JUSTIFICATION
DRIVEWAY GATES

Conservation Officer’s comments on the original scheme, received on the 25th of January 2023
Comments on the above planning and listed building consent applications.
The application site, Marlow House, is a Grade II listed building dating, from the list description, from the 15th century and located within the Lindfield Conservation Area. To either side of the building are other listed buildings- Everydens to the north is listed Grade II and dates from the 17th century, and Limes Cottage to the south, also Grade II listed, dates from the 16th century. Marlow House would be considered to be within the settings of these buildings.
Towards the rear (western) end of the garden of Marlow House, a three bay garage structure has been commenced but not completed. Planning permission for an oak framed detached garage was granted in 2014. This structure is shown as having timber cladding and a hipped clay tiled roof, but only the base of the walls appears to have been completed.

Re: GH342, Marlow House, Lindfield – Draft response to MSDC Conservation Officer

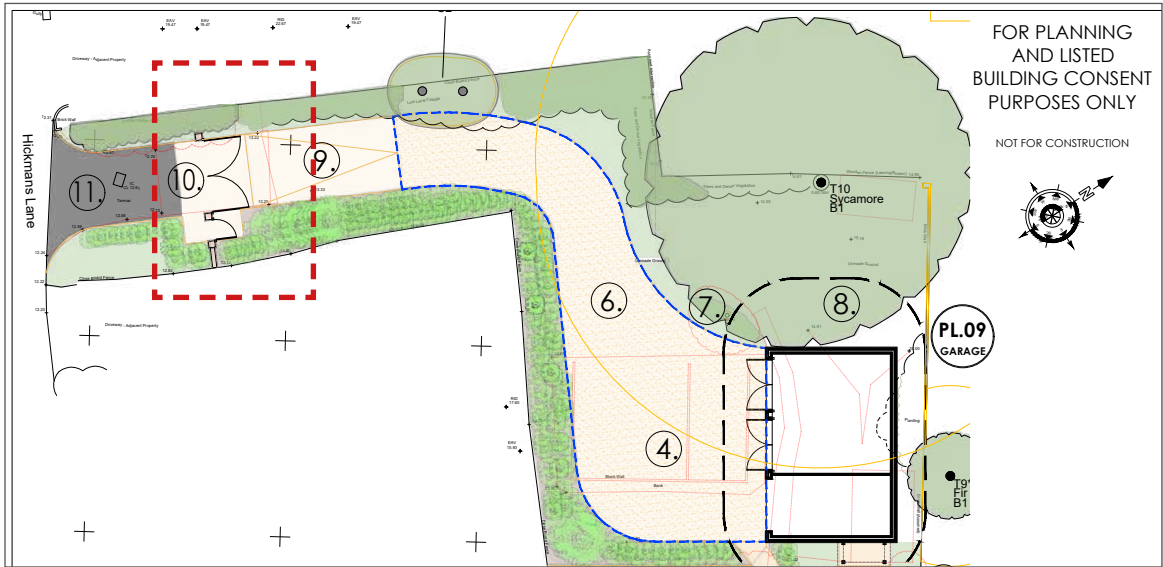
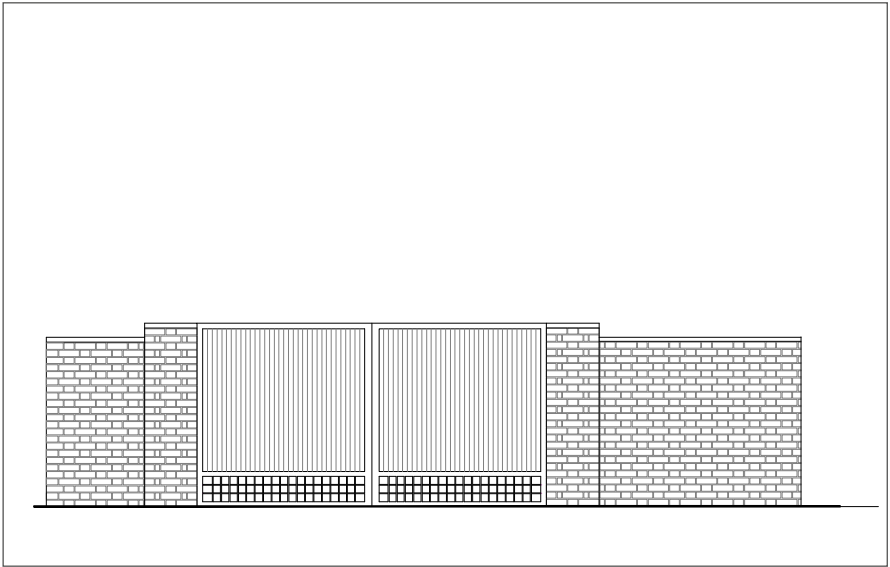
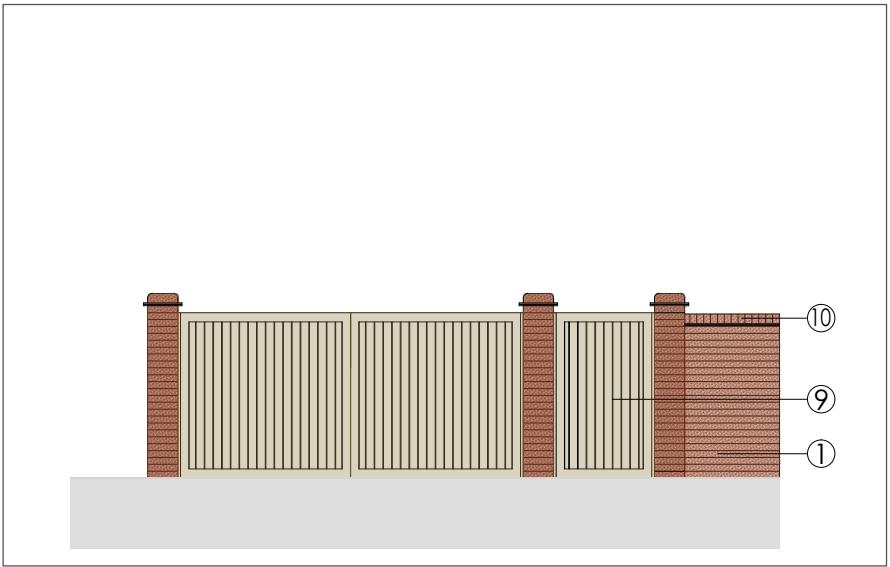
Different timber gates and brickwork piers to those in the approved scheme have been constructed, and are a deviation from the approved scheme. They are however of a modest design in keeping with the vernacular of the proposed detached garage building, and sympathetic to their Listed Building and wider Conservation Area setting, as outlined in the supporting HCUK heritage statement.

JUSTIFICATION LANDSCAPING

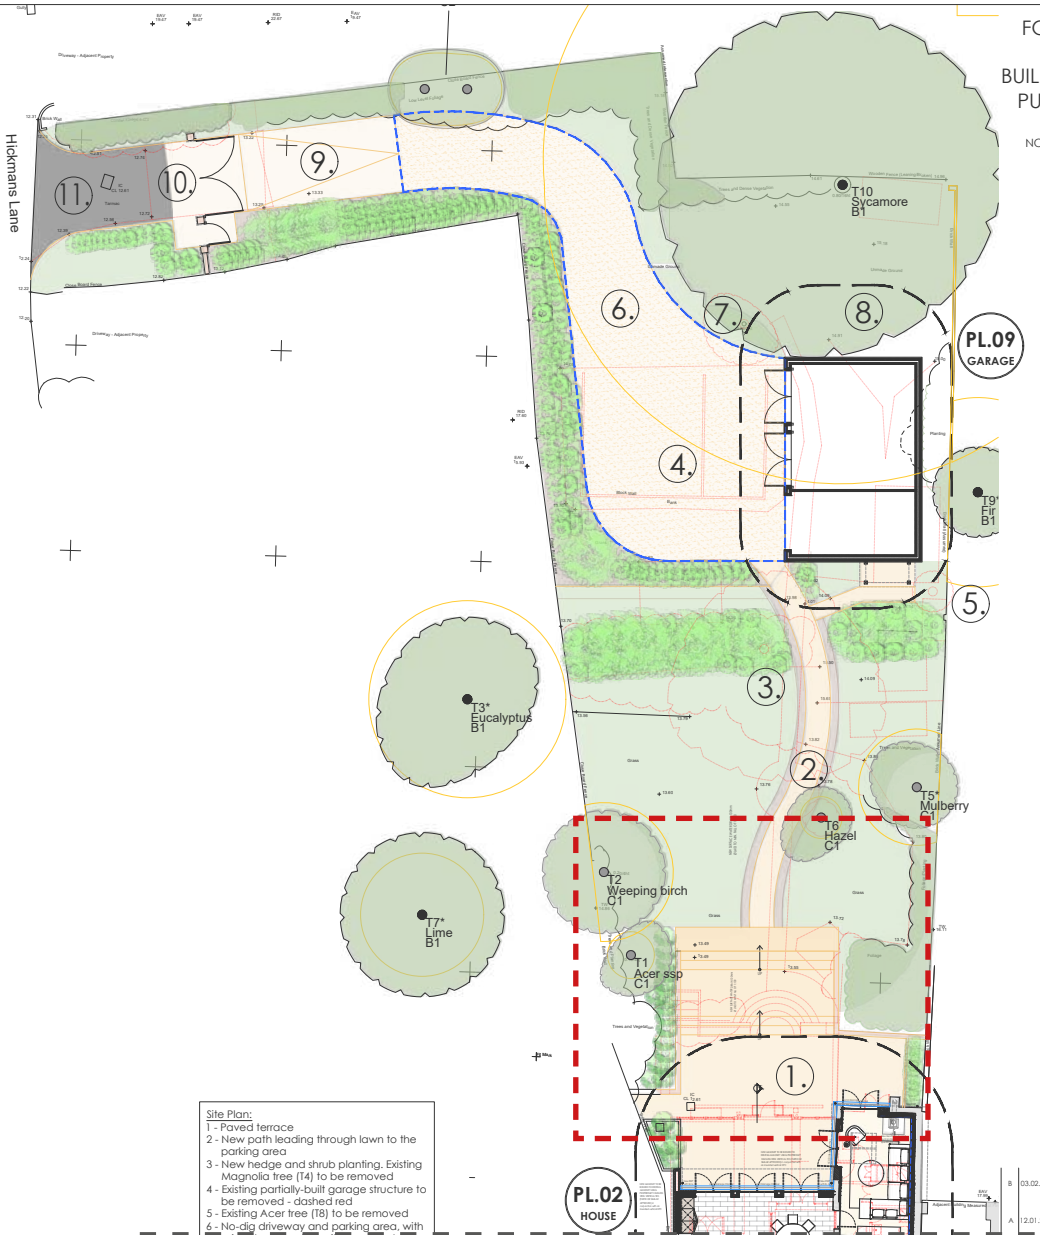
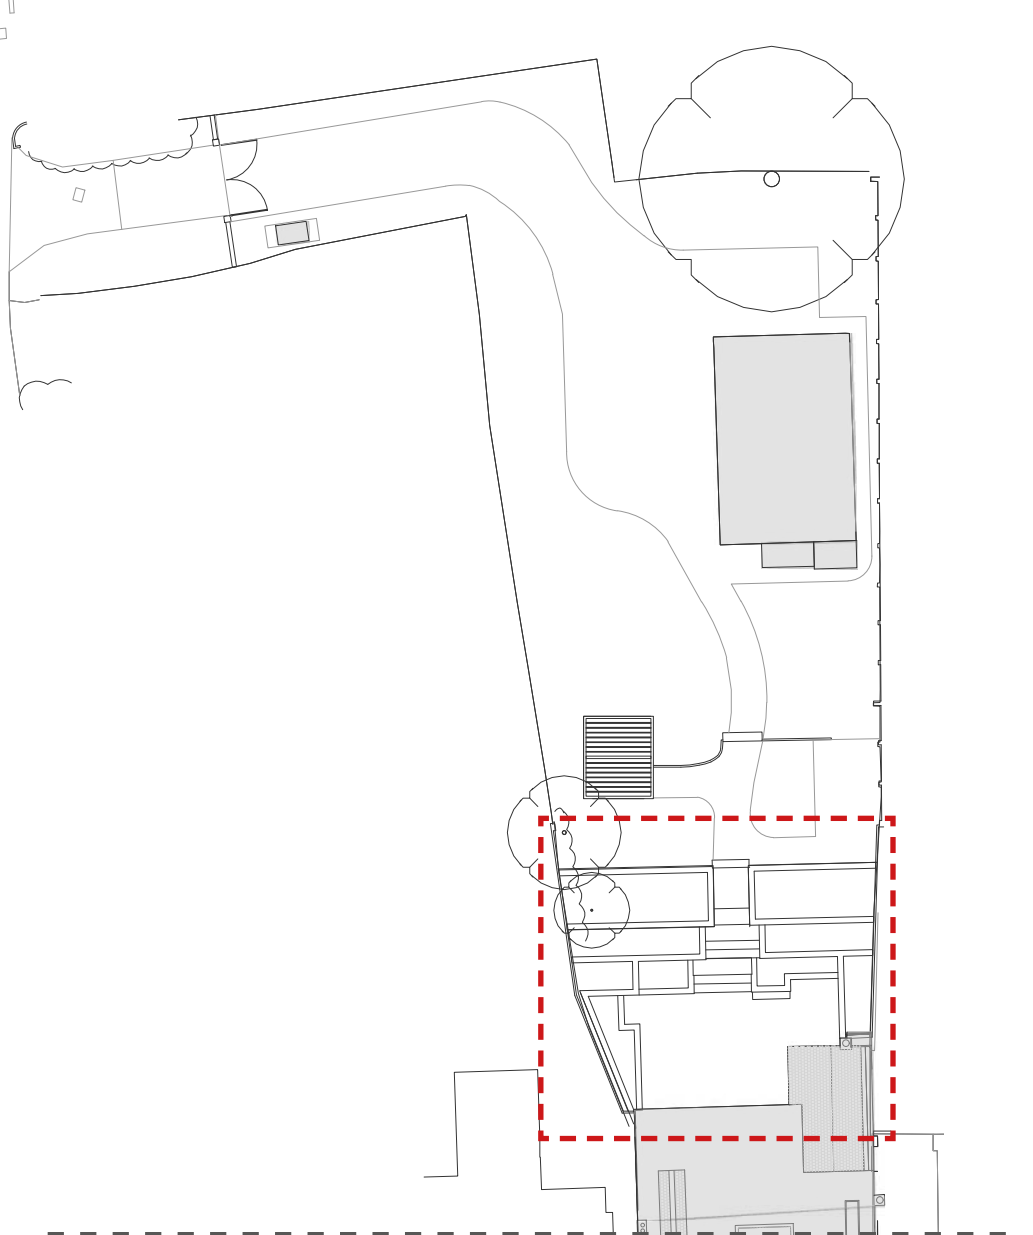
The hard and soft landscaping to the rear garden deviates from the approved scheme. However, it still enhances the setting of the building and protect the character and integrity of the Conservation Area, as outlined in the supporting HCUK heritage statement.

Refer to supplemented drawing D8 Rev B by Rachel Goozee Garden & Planting Design for further details on current hard and soft landscape design.
